Recommendations on Equipment Specification by CTO  
Paul L. LINKER, USN

PROJECT EARPOP

Subj: Recommendations on Specifications for the New Buffered-Tape Data Storage System

## BTM-9 Cabinet Changes

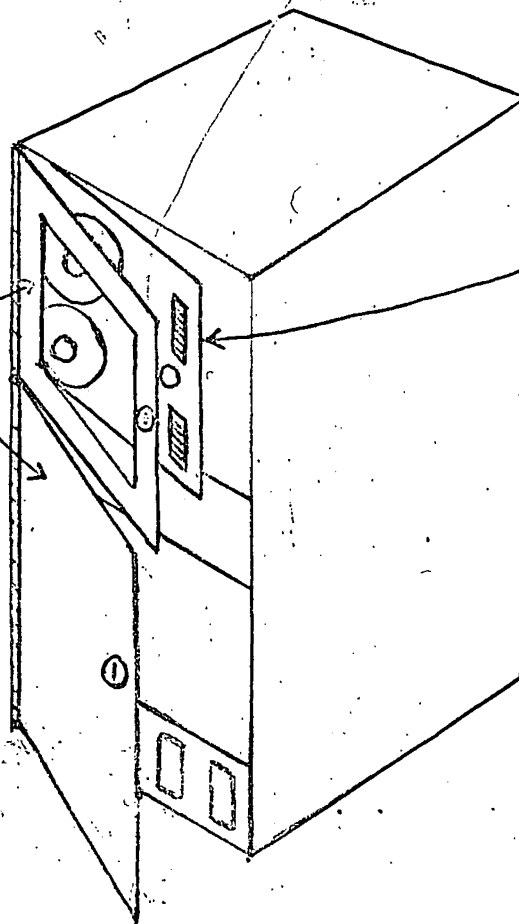
In view of the inaccessability of the Reel Servo Electronics, I recommend that the TM-9 transport be placed on a hinge as shown in encl. (1). This not only provides accessability to the reel servo electronics, but it will make tape guide replacement and capstan motor removal a one man job instead of a two man job. Also greater accessability would be provided to the transport control circuits; reel motors, and vacuum pump. In view of the time and work involved in placing a scope probe on inaccessible circuits, I recommend that all cable lengths be increased on the unhinged units within the cabinet. The increase in length should be sufficient to allow the units to be removed from their rack and worked on without disconnecting their cables. This recommendation applies specifically to the following units:

Bye-57856-68 ENCLOSURE (2)

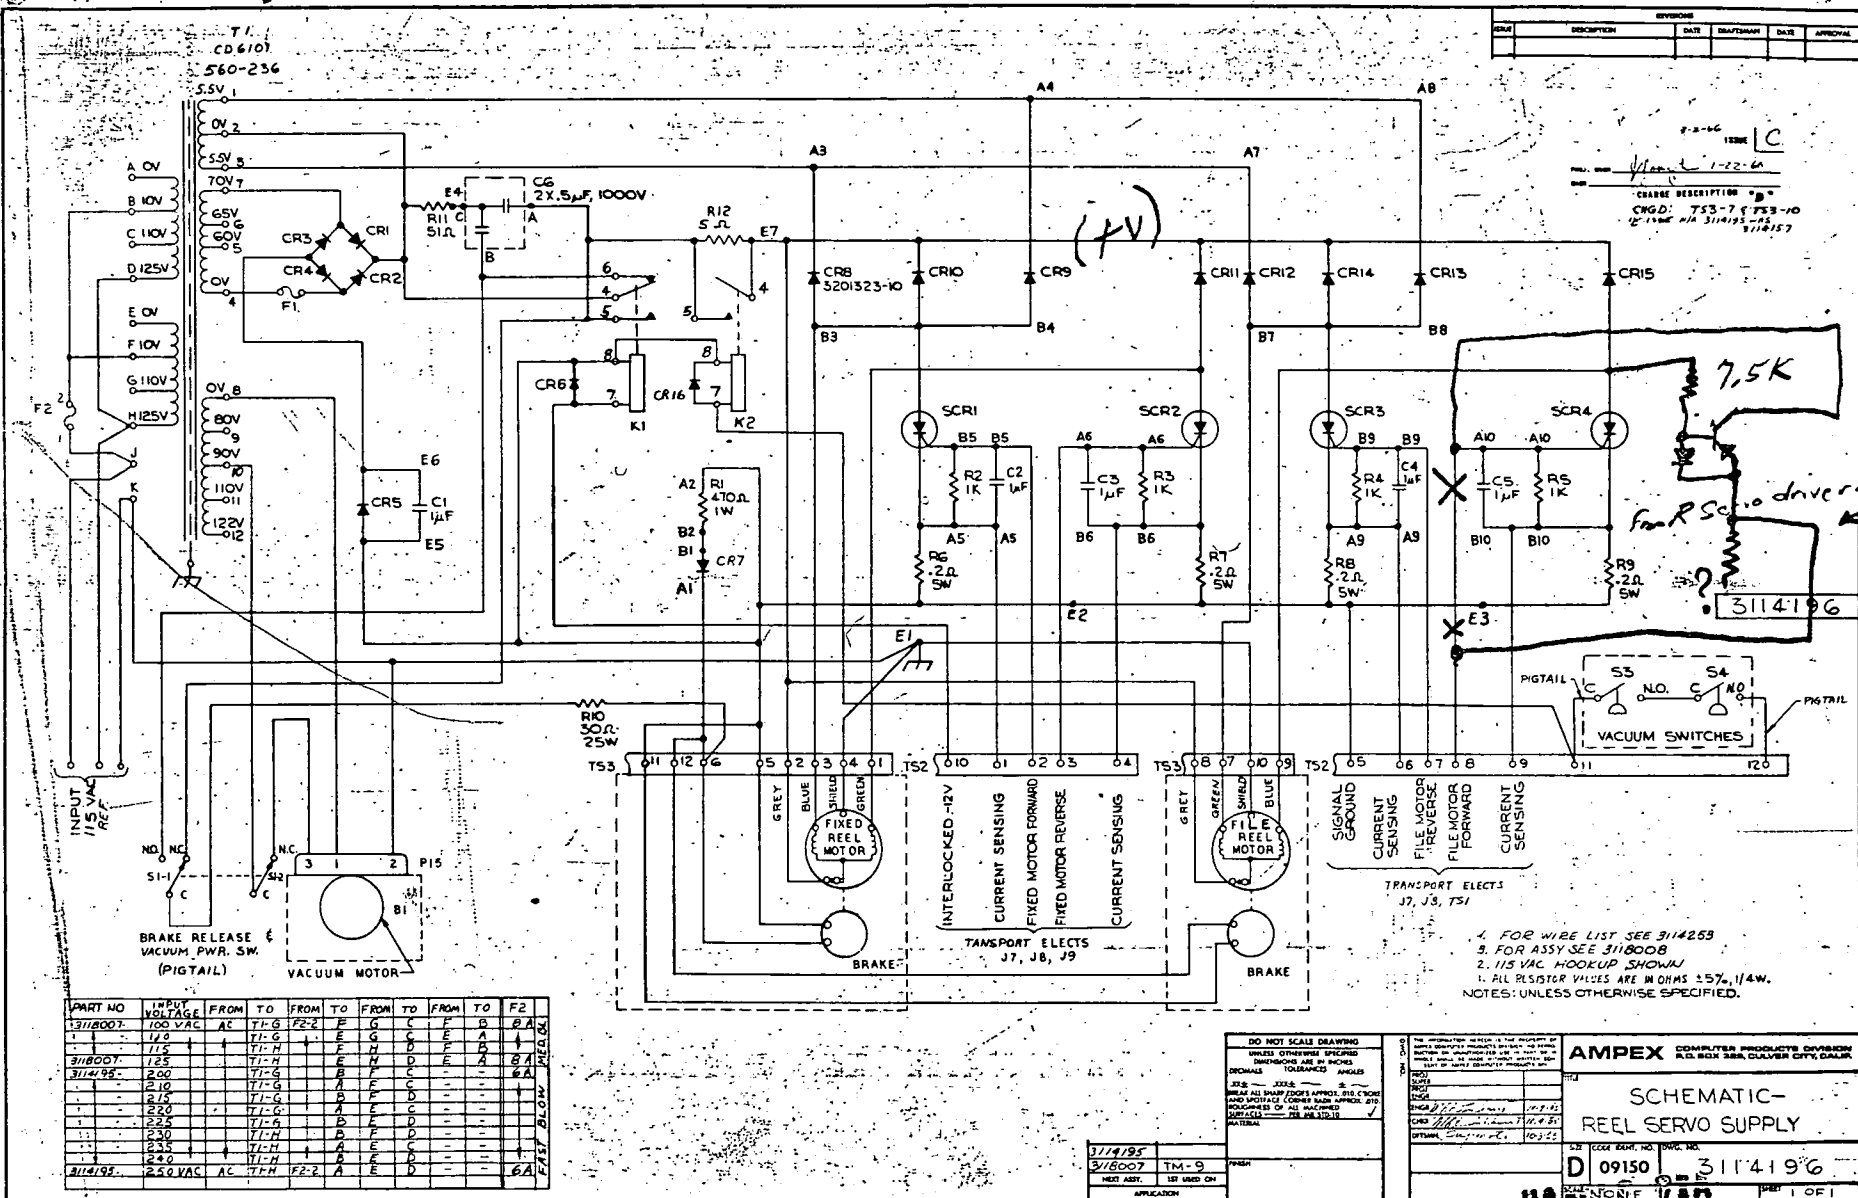
a. In the Reel Servo Electronics, there are additional transistor circuits to control the voltage that their respective SCR's fire. With this additional circuitry, the SCR can fire only at the null of the power supply voltage. Compare drawing No. 3114196 in ref (b) with enclosure (2). On the enclosure's right side, I have drawn as much of the transistor circuitry that I could trace out for one SCR. There are four of these circuits in our machine.

HANDLE VIA  
BYEMAN  
ENCLOSURE (3)

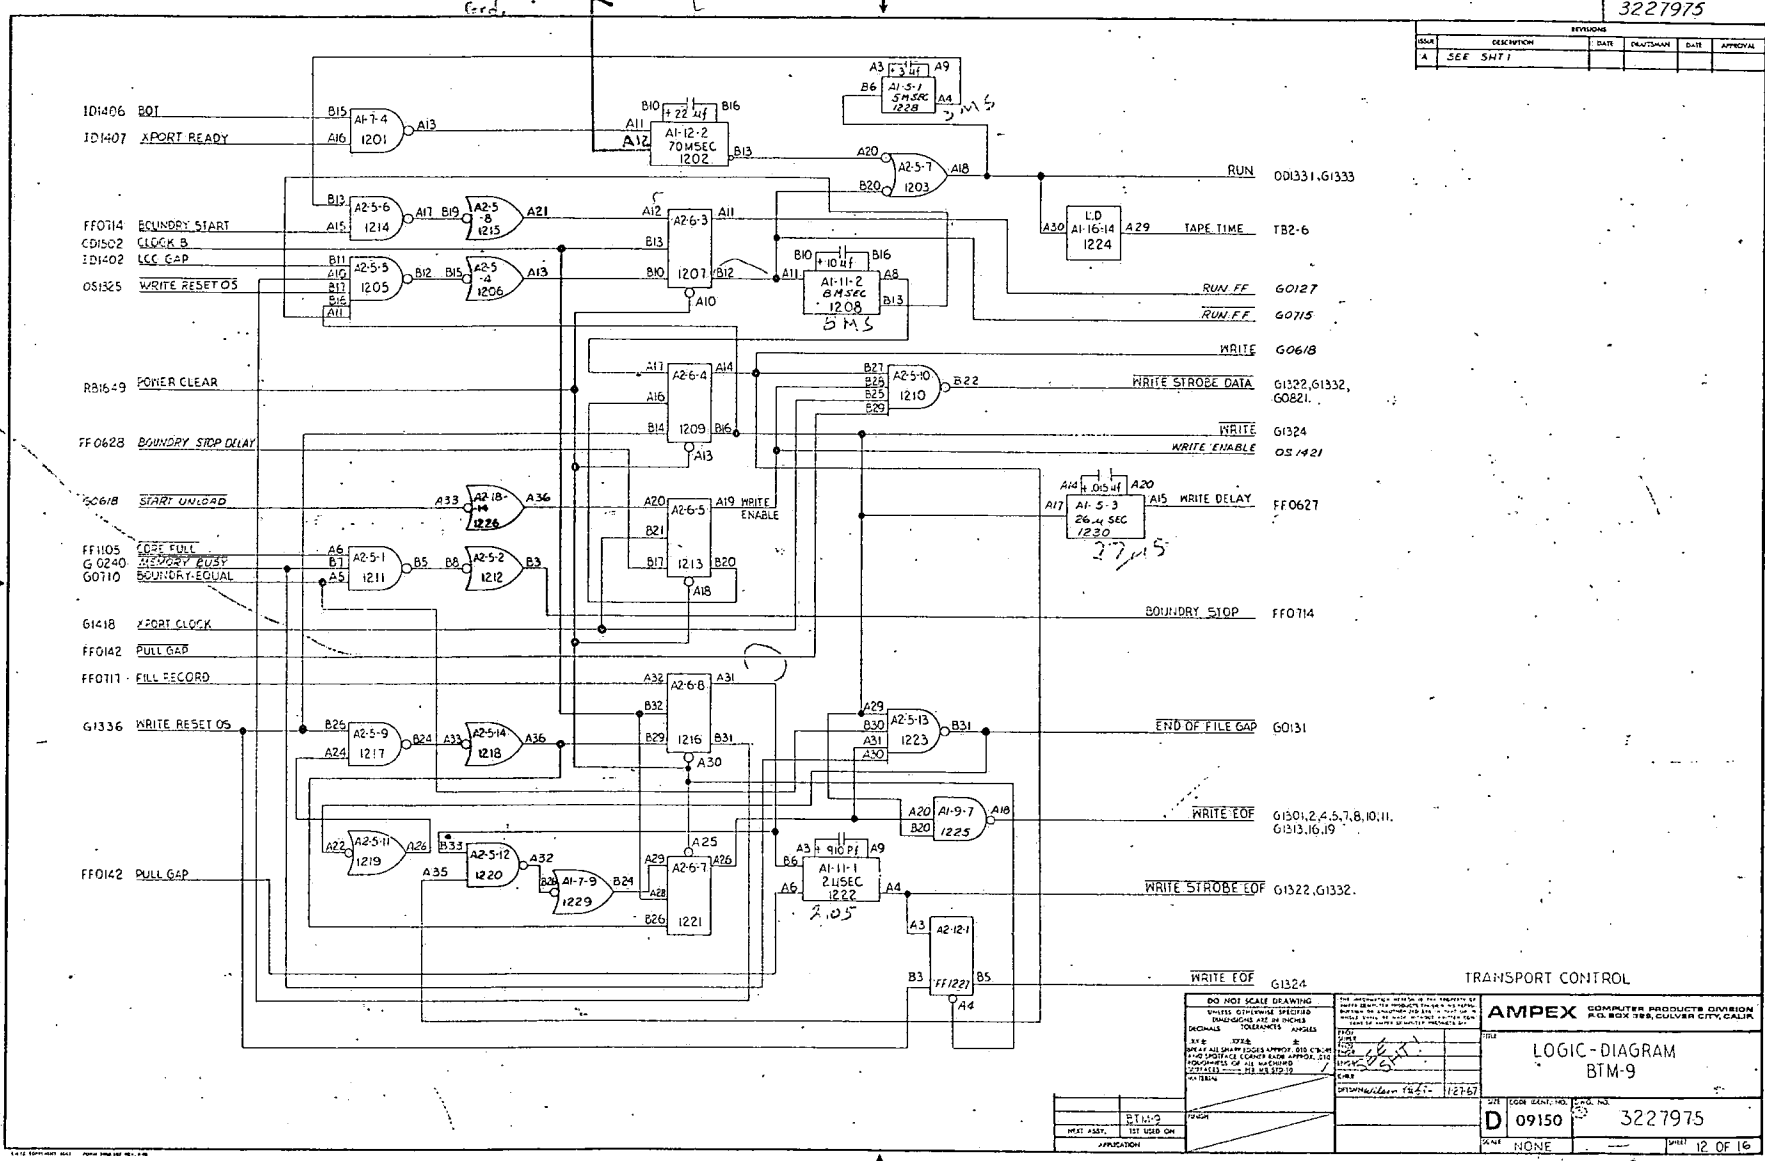
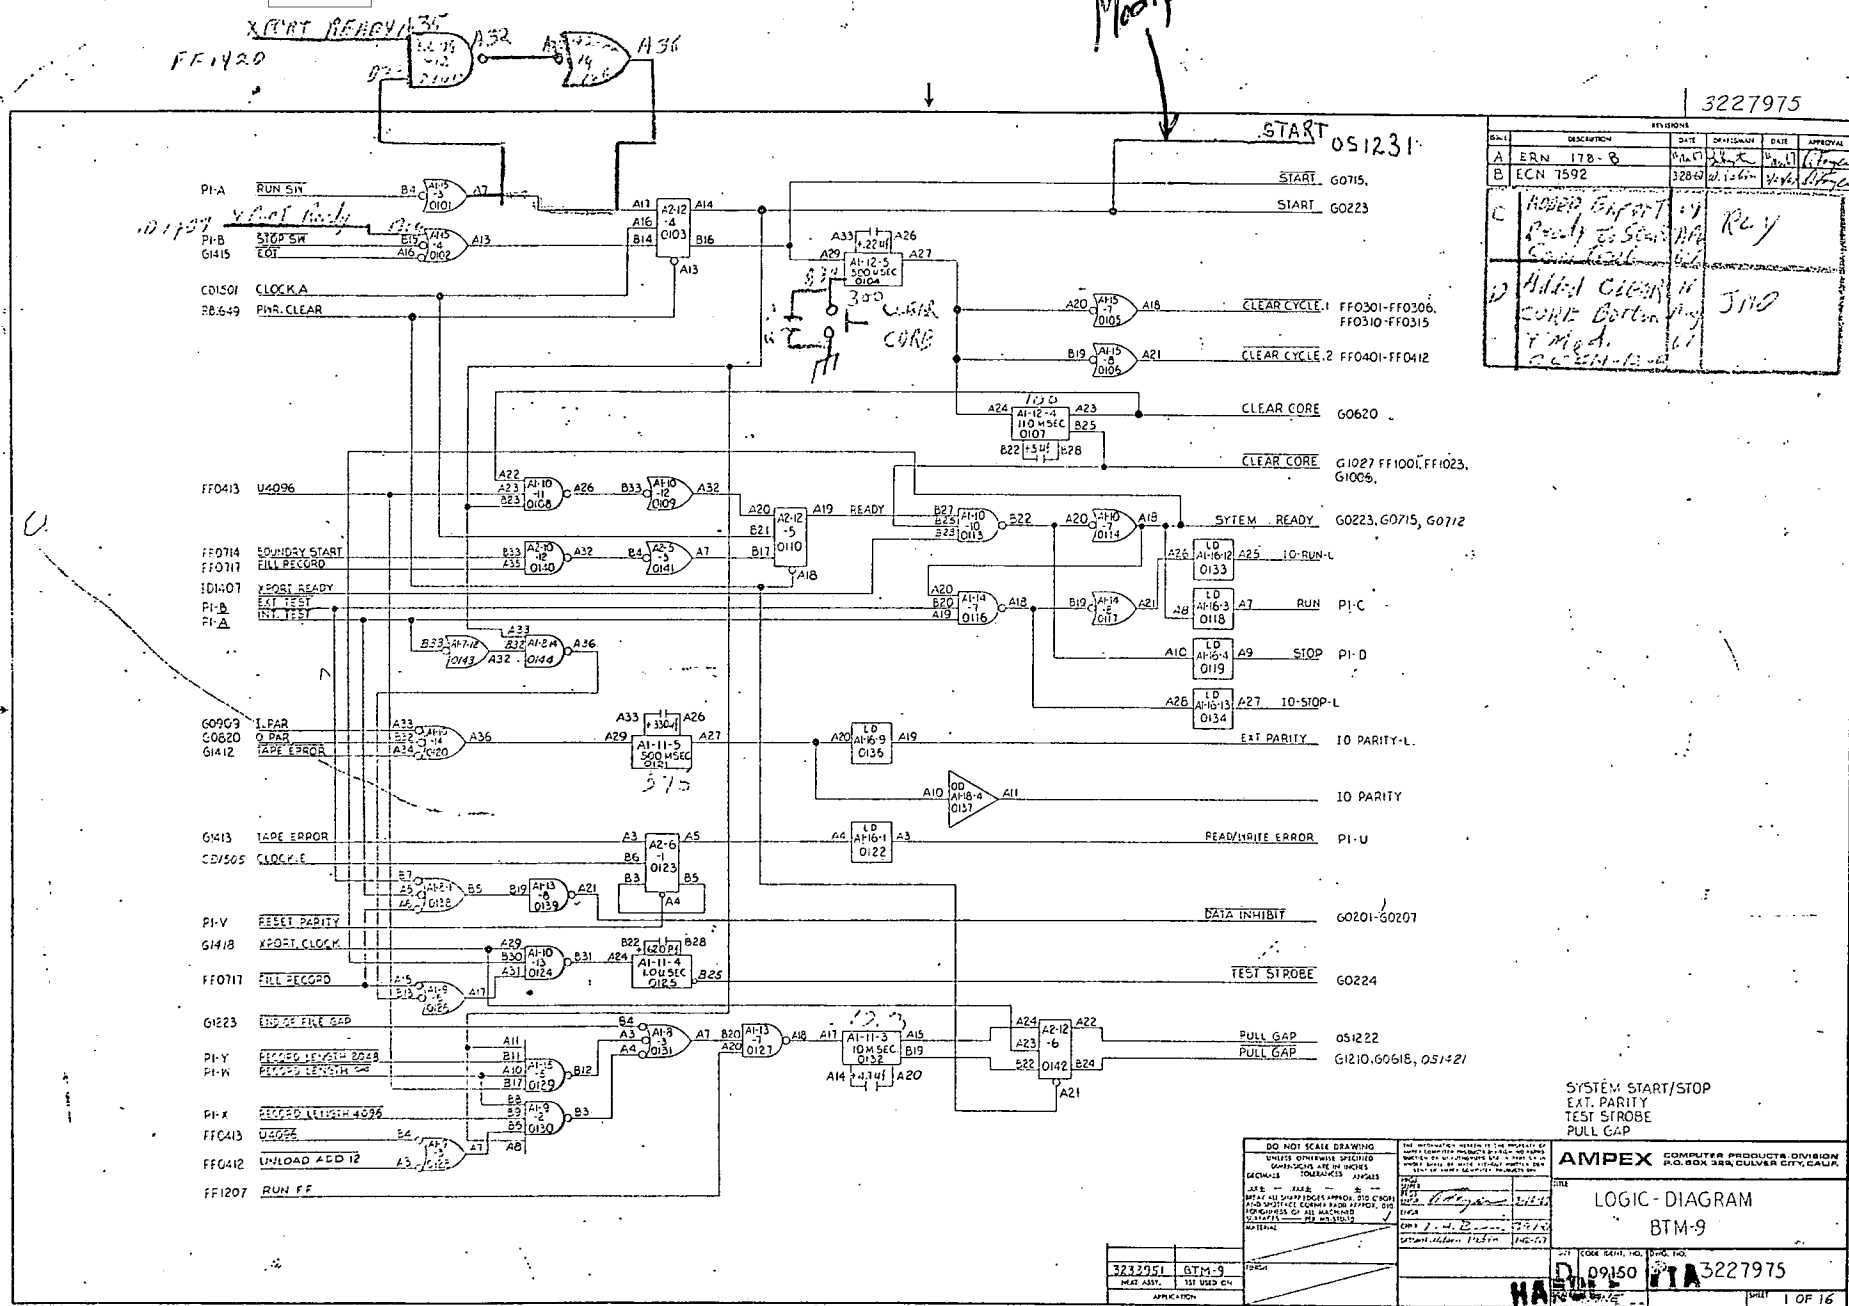
a. A gap of erased tape 3 to 5 inches long must be obtained between the header/trailer and the EOF, or generate this gap after the EOF. This is because the normal IRG on the BTM-9 tape is  $3/4$  inch; and if a header/trailer was replaced, the EOF would be erased because the erase head on the TM-11 is  $3/4$  inch ahead of the write. Since the SEL TCU is hard-wired to put this gap before an EOF, the best place for the gap on the BTM-9 tape would be between the header/trailer and the EOF. The main advantage to this placement would be that the same basic program could be used to edit a BTM-9 tape or an SEL tape. However, without spare gates to put the gap before the EOF, I was able to obtain an erased gap after the EOF. This gap is generated by firing the 70ms.SS (A1-12-2) 300 ms. after clearing the start FF. The circuit modifications that I have made to acquire this gap are shown in enclosure (3) (a spare SS A1-5-5 is now used). A 300 ms. delay in firing the 70 ms. SS will permit the following to occur before erasing 4 inches of tape:

8. Since it is impossible to edit a BTM-9 tape without the gap described in paragraph 4.a. above, I recommend that the modification shown in enclosure (3) be approved for inclusion in the existing BTM-9's. This would serve as an interim solution to editing BTM-9 tapes until Ampex could furnish a modification to place the gap ahead of the EOF.
